Subject: Interstate 4 from West of US 27 to the Polk/Osceola County Line Value Engineering Study  
Recommendation Dispositions

FM: 201210-3

Please see below for our management action dispositions for the recommendations found on Table 1.4-1 of the Value Engineering Study Report for I-4 from West of US 27 to the Polk/Osceola County Line.

PROJECT:	<i>Florida Department of Transportation</i> <b>I-4 from West of US 27 to Polk/Osceola County Line</b> <b>FPN #201210-3</b>	ALTERNATIVE NO.:	<b>BR-1 (RD-02)</b>
DESCRIPTION:	<b>Provide at-grade intersection US 27 at Frontage Road</b>	SHEET NO.:	<b>1 of 8</b>

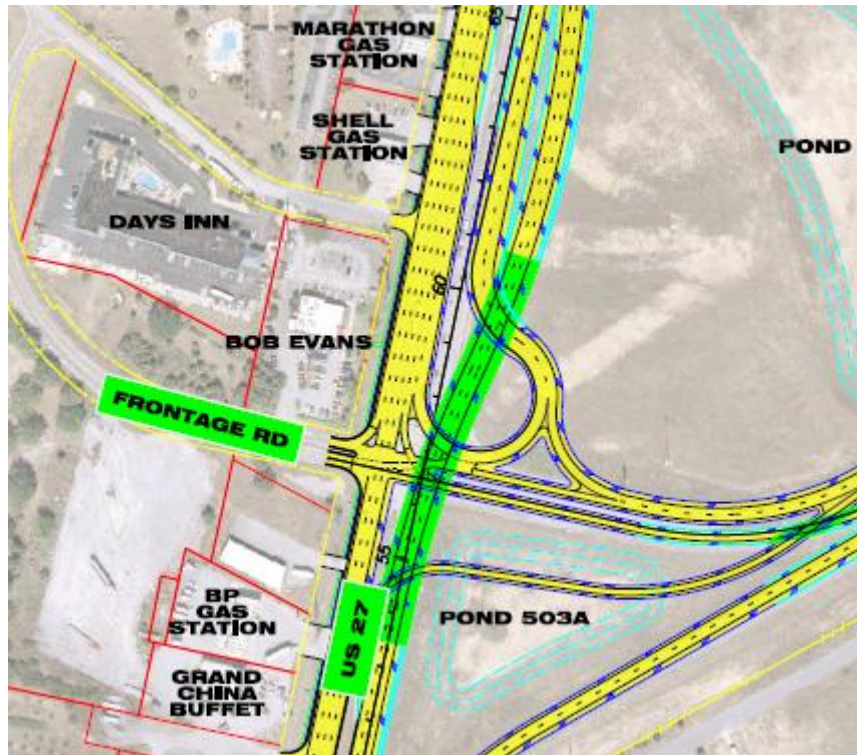
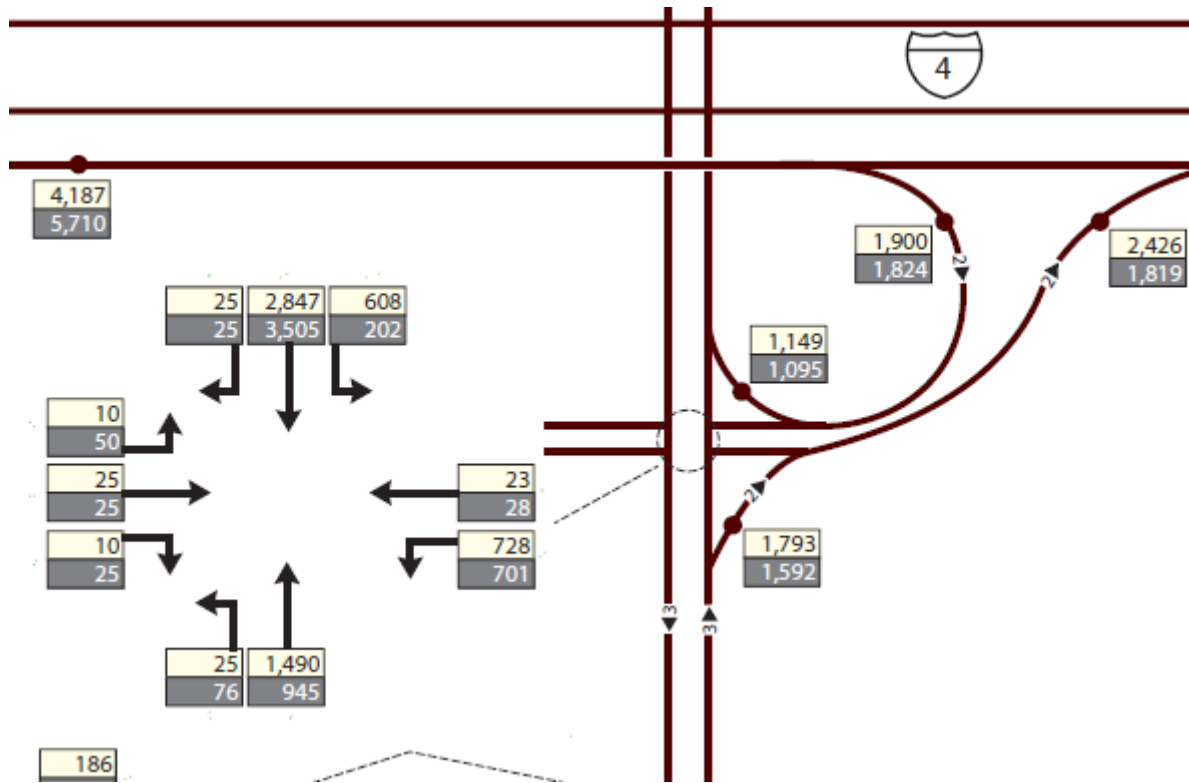
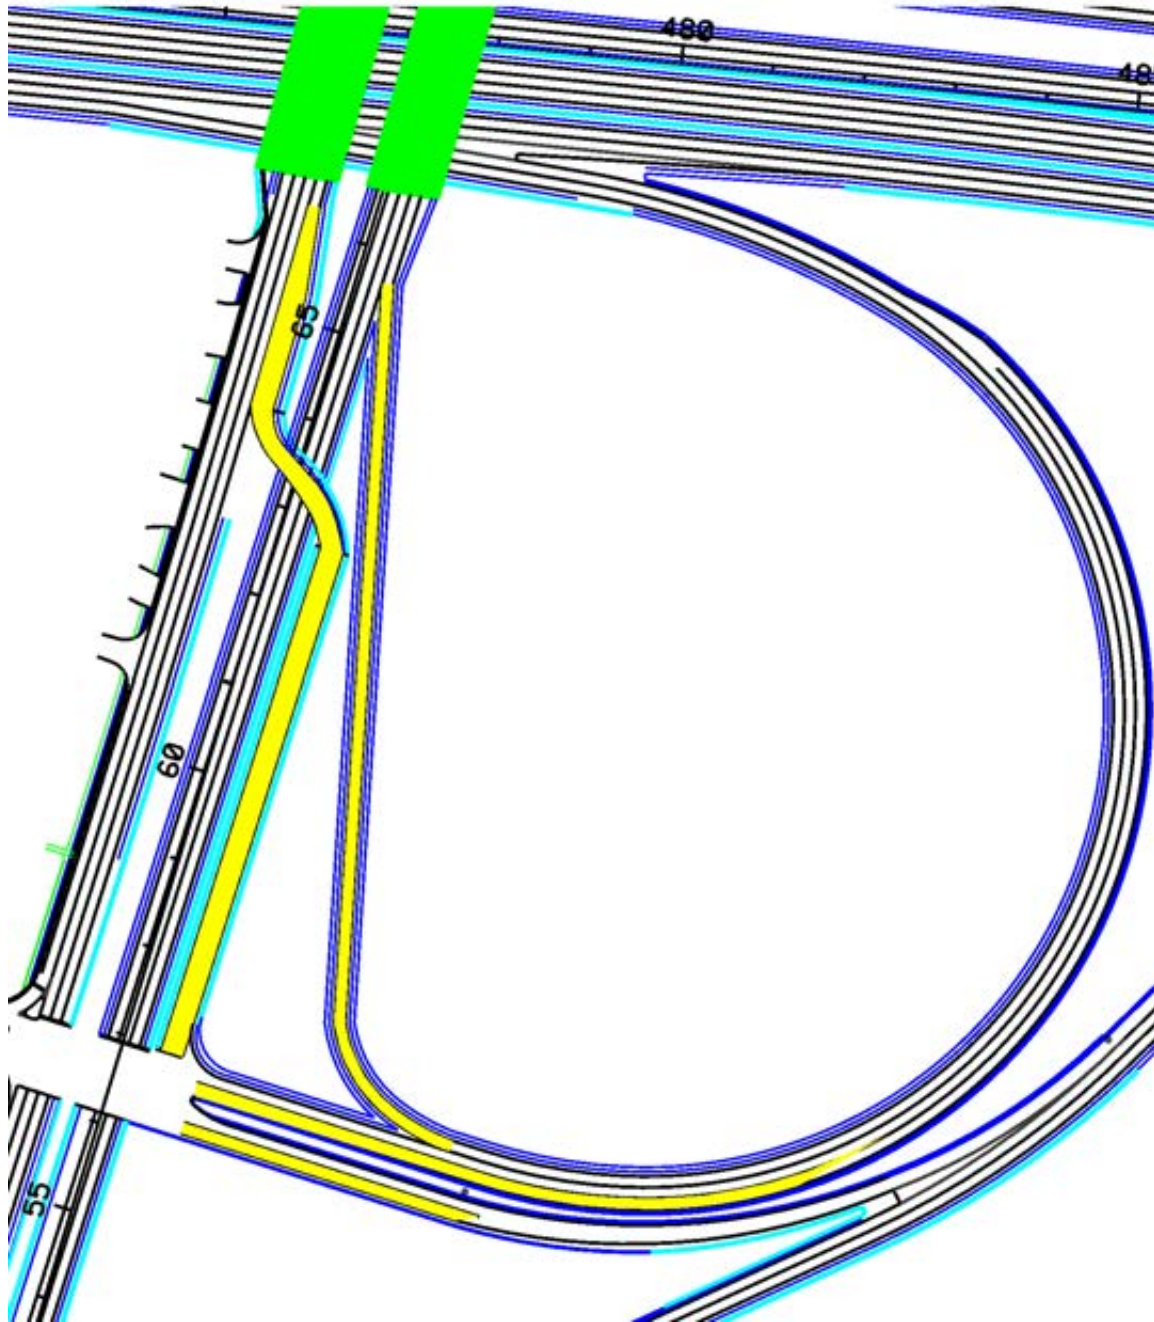
Recommendation BR-1: The alternate is to provide an at-grade intersection with a partial Continuous Flow Intersection to accommodate US 27 SB left turn at Frontage Road. The alternate is to provide an at-grade intersection which relocates the SB US 27 left turn lane east of NB US 27 lanes. This partial continuous flow intersection will require a crossover signal to allow for the left turn lanes to crossover the NB US 27 lanes. The U-turn lane for SB US 27 to NB US 27 will be eliminated. The I-4 EB exit ramp to NB US 27 connection will be relocated to approximate crossover signal location. The structure for NB US 27, the structure for EB I-4 On Ramp and the EB I-4 to SB US 27 movement are all eliminated. A 780 foot lane will be added for the WB approach to the signal and a receiving lane will be added to accommodate the SB US 27 left turn.

The alternate is to provide an at-grade intersection with a partial Continuous Flow Intersection to accommodate US 27 SB left turn at Frontage Road. The alternate is to provide an at-grade intersection which relocates the SB US 27 left turn lane east of NB US 27 lanes. This partial continuous flow intersection will require a crossover signal to allow for the left turn lanes to crossover the NB US 27 lanes. The U-turn lane for SB US 27 to NB US 27 will be eliminated. The I-4 EB exit ramp to NB US 27 connection will be relocated to approximate crossover signal location. The structure for NB US 27, the structure for EB I-4 On Ramp and the EB I-4 to SB US 27 movement are all eliminated. A 780 foot lane will be added for the WB approach to the signal and a receiving lane will be added to accommodate the SB US 27 left turn.

**Not Accepted.** The crossover intersection appears to operate well but the main intersection with US 27 and the EB off-ramp is failing during the PM peak. An at-grade, partial CFI intersection is not recommended at the US 27 and EB Ramps intersection.

PROJECT:	<b>Florida Department of Transportation</b> <b>I-4 from West of US 27 to Polk/Osceola County Line</b> <b>FPN #201210-3</b>	ALTERNATIVE NO.:
		<b>BR-02 (RD-01)</b>
DESCRIPTION:	<b>Provide at-grade intersection at I-4 WB off ramp/US 27 NB on ramp/Burger King access</b>	SHEET NO.: 1 of 7

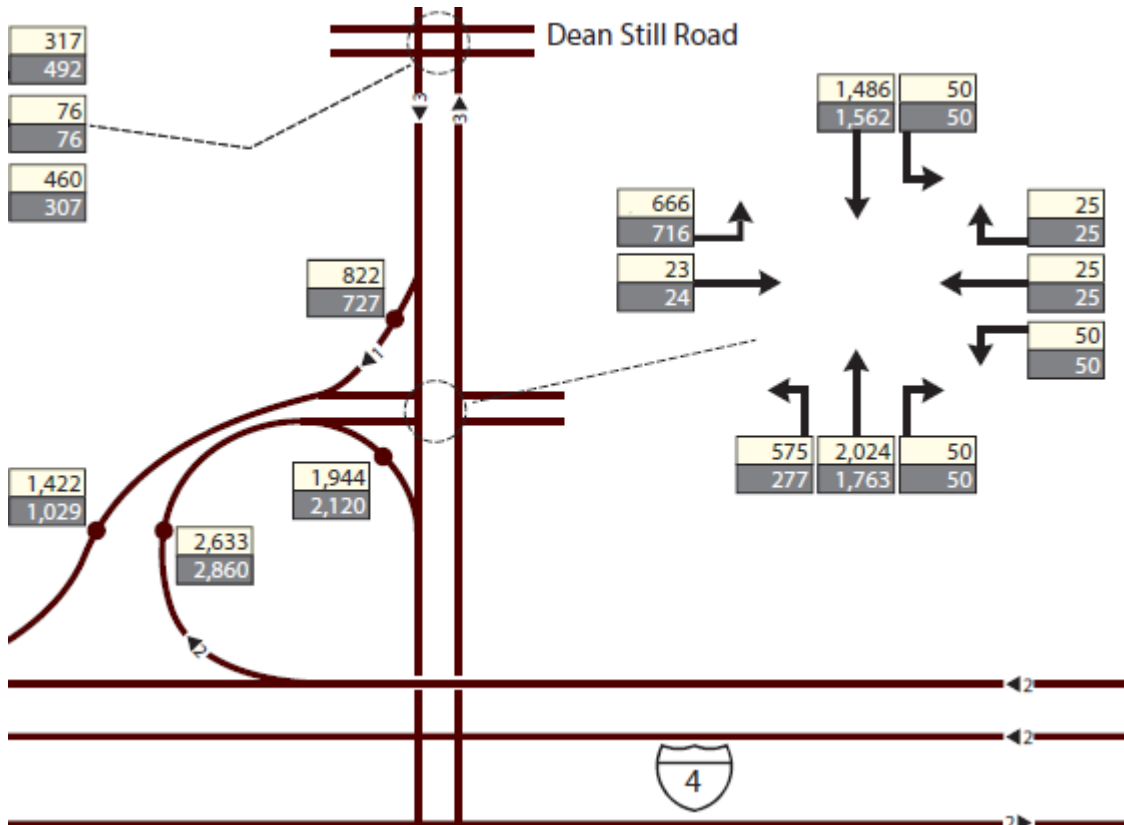
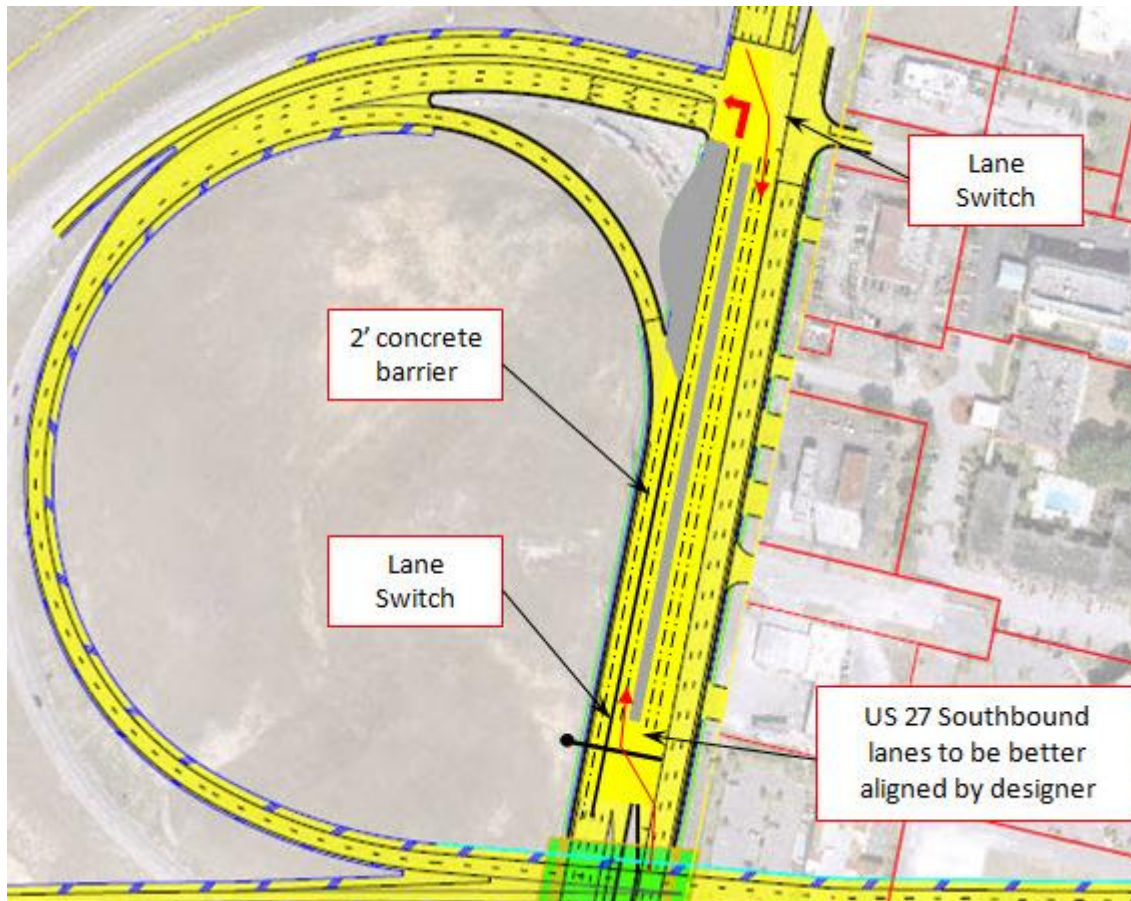
Recommendation BR-02: The alternate is to provide an at-grade intersection which relocates the NB US 27 left turn lanes west of SB US 27 lanes. This partial continuous flow intersection will require a crossover signal to allow for the left turn lanes to crossover the SB US 27 lanes. The u-turn lanes and turn out pavement for NB US 27 will be eliminated. The relocation of the NB left turn lanes will require the WB I-4 ramp to SB US 27 to be extended.

The alternate is to provide an at-grade intersection which relocates the NB US 27 left turn lanes west of SB US 27 lanes. This partial continuous flow intersection will require a crossover signal to allow for the left turn lanes to crossover the SB US 27 lanes. The u-turn lanes and turn out pavement for NB US 27 will be eliminated. The relocation of the NB left turn lanes will require the WB I-4 ramp to SB US 27 to be extended.

**Not Accepted.** The crossover intersection appears to operate well but the NB crossover will require 2 NB left-turn lanes crossing 4 SB thru lanes. Four thru lanes are needed SB at the EB ramps and it is most practical to start this 4<sup>th</sup> lane upstream at the WB ramp intersection. The WB off-ramp will also require a triple bypass right turn. The main intersection with US 27 and the WB off-ramp operates at an LOS C during both peak hours, but requires a triple left turn from the off-ramp.

From a traffic operations perspective the proposed at-grade, partial CFI intersection at the WB Ramps is plausible but would need further evaluation of the required roadway geometry. Given that the CFI is not a viable alternative at the EB Ramps, another alternative is needed, one that will probably require a u-turn at the WB Ramps. Building a CFI at the WB Ramps, however, precludes a u-turn movement, limiting your options at the EB Ramps.

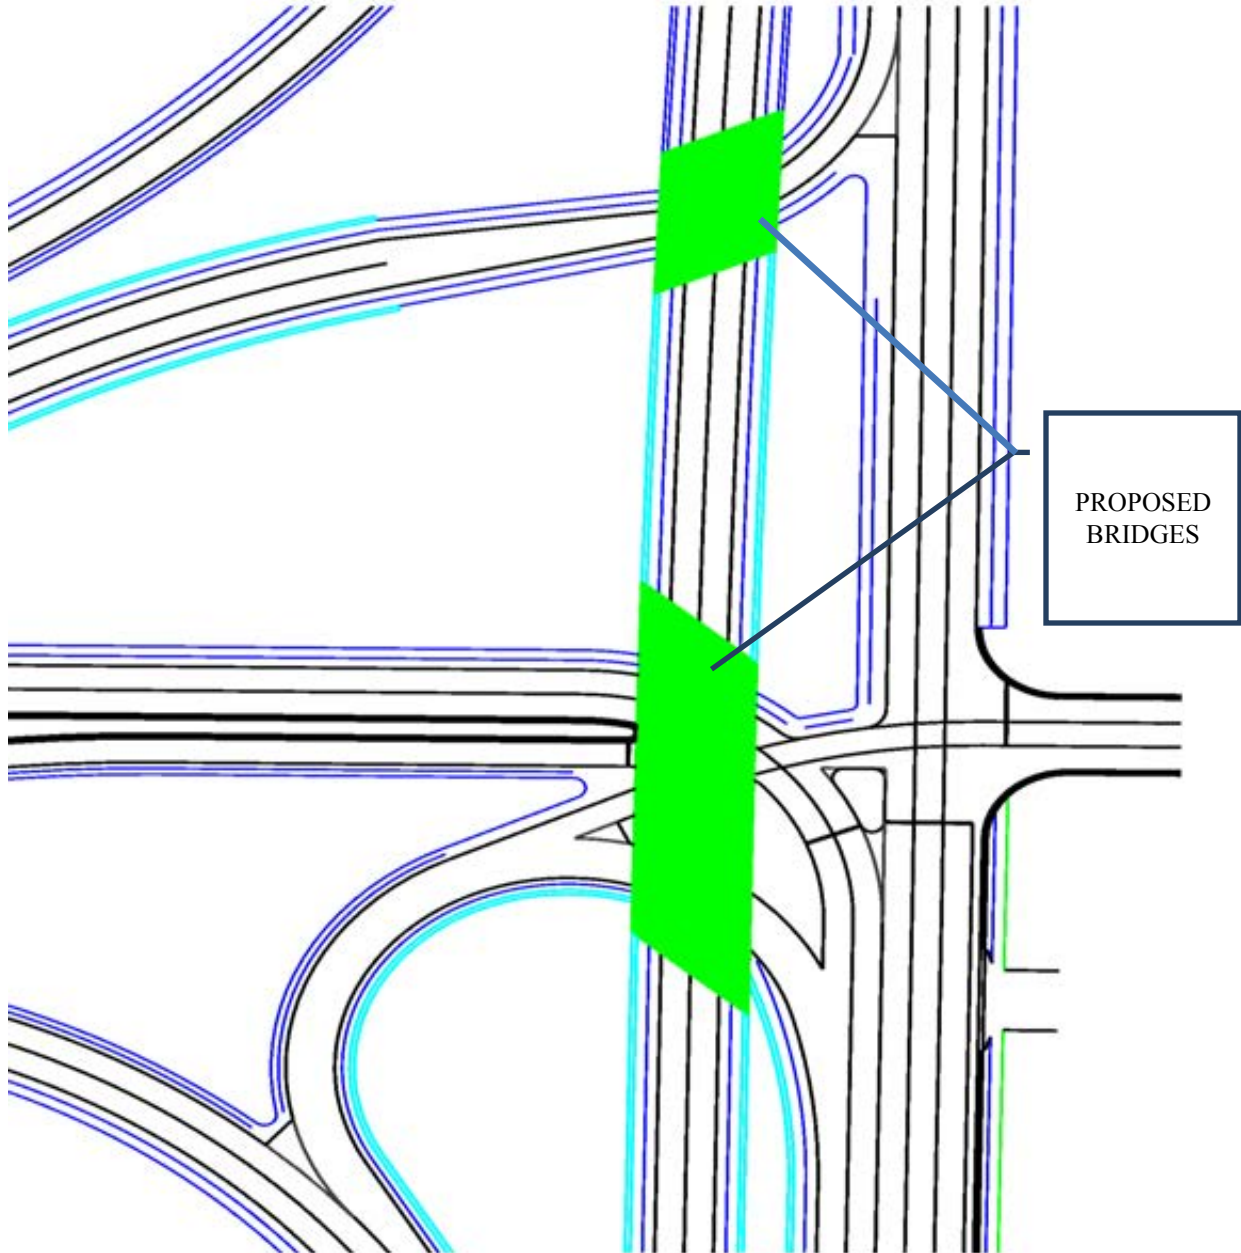
Recommendation BR-04: The alternate design proposes building two single span bridges over Westbound I-4 to North US 27 Ramp and over Burger King access and to connect/plug the bridges with MSE walls.

The design of the alternate includes building one 70' long single span bridge over Westbound I-4 to North US 27 Ramp and one 175' long single span bridge over Burger King access. This alternative will save 635' +- long bridge length compared with 880' bridge in original design.

**Accepted.**

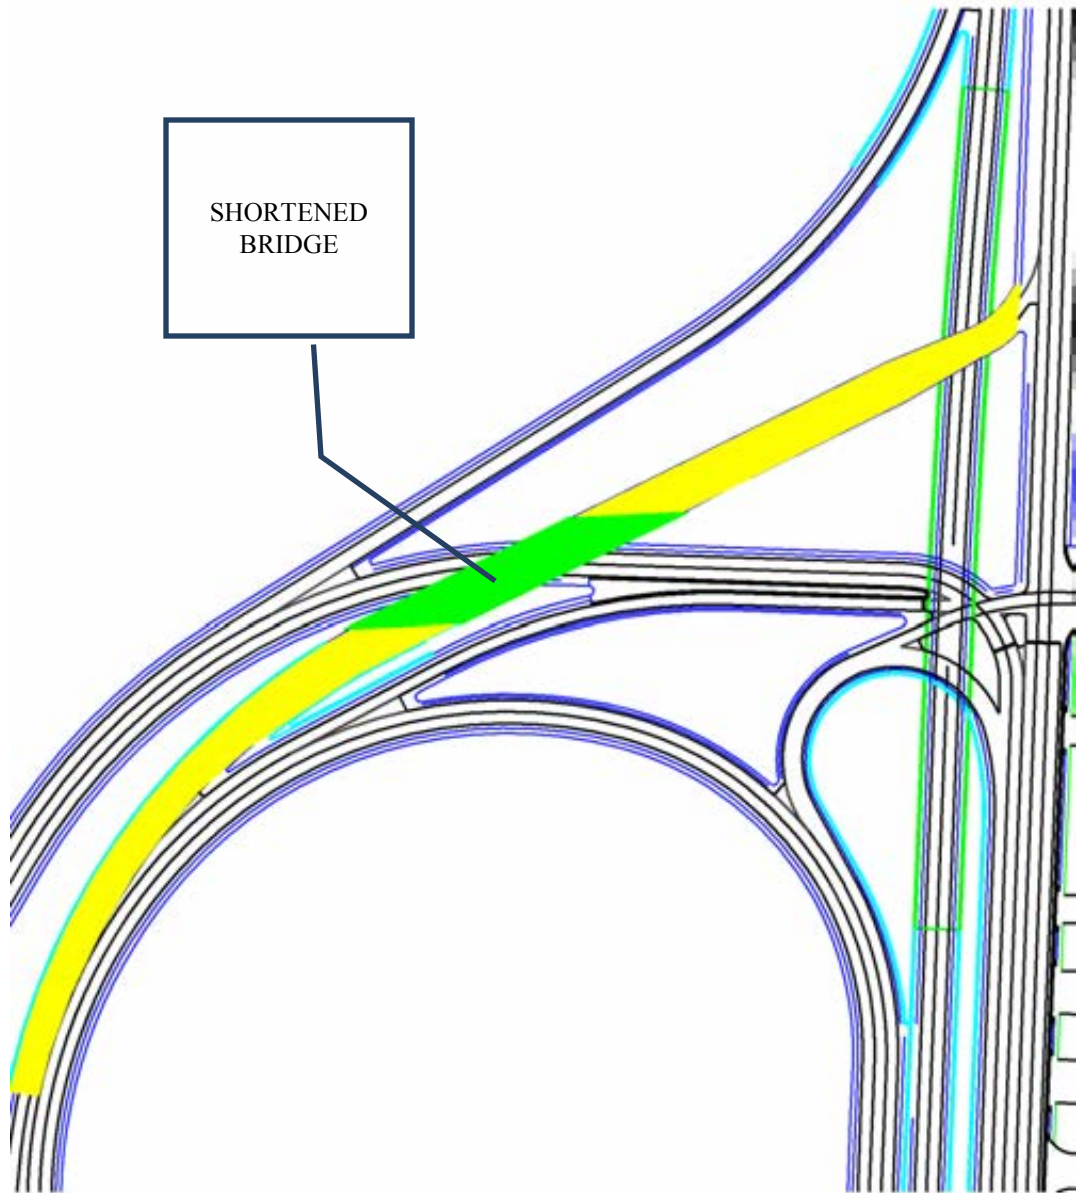
Recommendation BR-05: The alternate design is to shift the alignment of westbound I-4 ramp to US 27 North towards the Burger King access and reduce the bridge length.

**Accepted. Bridge length can be reduced some, but sight distance and clearzone needs to be maintained.**
